Addendum #1

Directorate of Facilities Engineering

12 June 2015

Calais Armory Renovation, 119 Calais Avenue, Calais, Maine, Project Number 23SR14-444-D, BGS Project Number 2147, Bid Number 15-035.

ELECTRICAL SERVICE ENTRANCE EAST EXTERIOR ELEVATION
 SCALE: 1/4" = 1'-0"

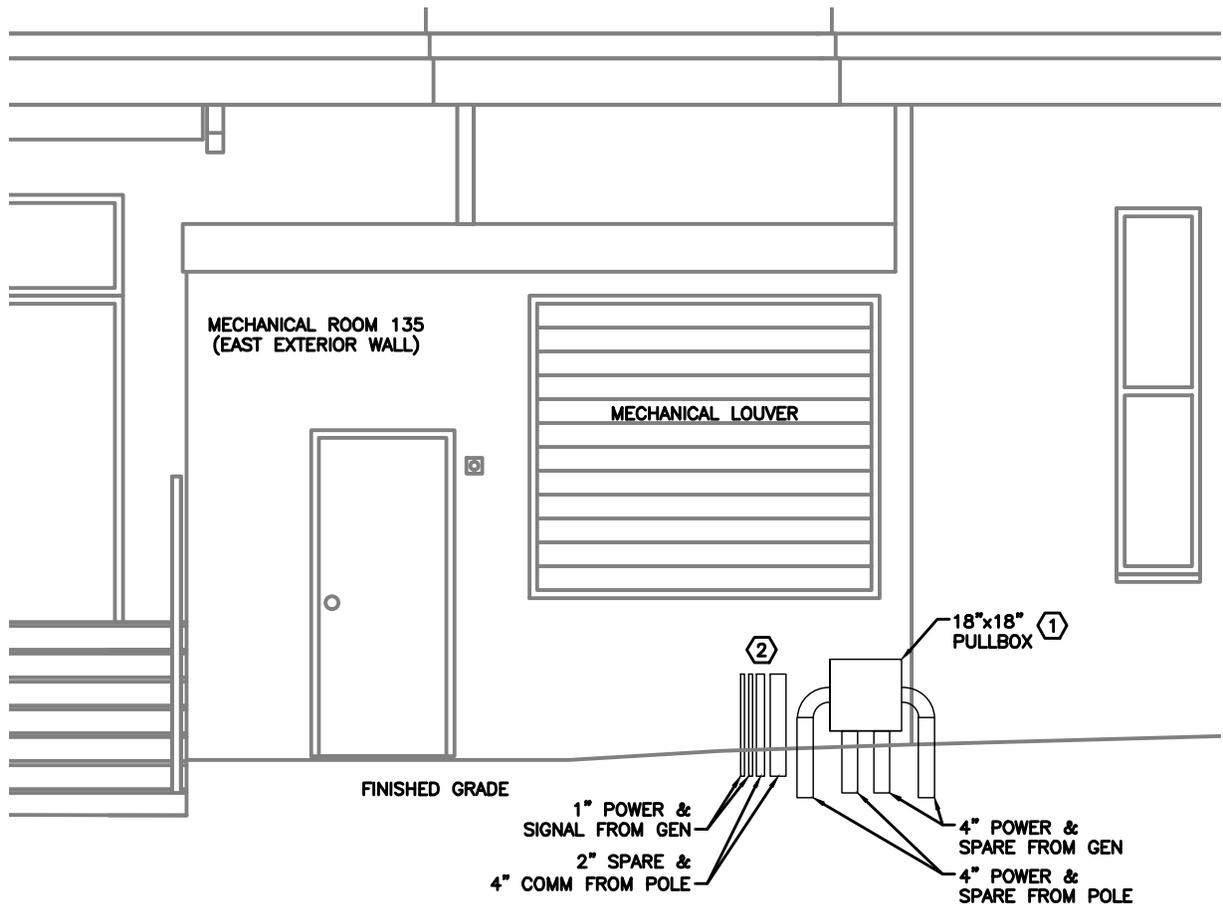
2. Question: We don't believe the SE conductors (and SE conduit) are permitted to travel through the building (Mech 135, former tank room) as described by the above drawing references and notes, without first passing through a SE disconnect switch, located at the point where the SE conductors cross the boundary from the exterior of the building to the interior of the building (which could be on the inside wall facing the street of Mech135). How shall we bid the new electrical service entrance conduit, SE conductors, and new service entrance distribution equipment, and also follow the National Electrical Code in this regard?

Answer: Service entrance conduits shall be completely encased in minimum of 2" concrete as they are routed through Mechanical Room 135 and into the Basement. Conduits in question include:

- (1) 4" from utility pole (utility service entrance)
- (1) 4" spare from utility pole
- (1) 4" from generator (generator service entrance)
- (1) 4" spare from generator

Concrete "curb" shall be located along floor adjacent to the northeast wall of Mech Room 135. Conduits shall be spaced 2-high-by-2-wide so a square curb approximately 1'x1' is formed. See new Electrical Sketches.

- ① PROVIDE NEMA 4X WEATHERTIGHT PULLBOX FOR SERVICE ENTRANCE CONDUITS.
- ② CONDUITS STUB UP AND ELBOW/90 INTO MECHANICAL ROOM WALL. PROVIDE LB FITTINGS AS NECESSARY.
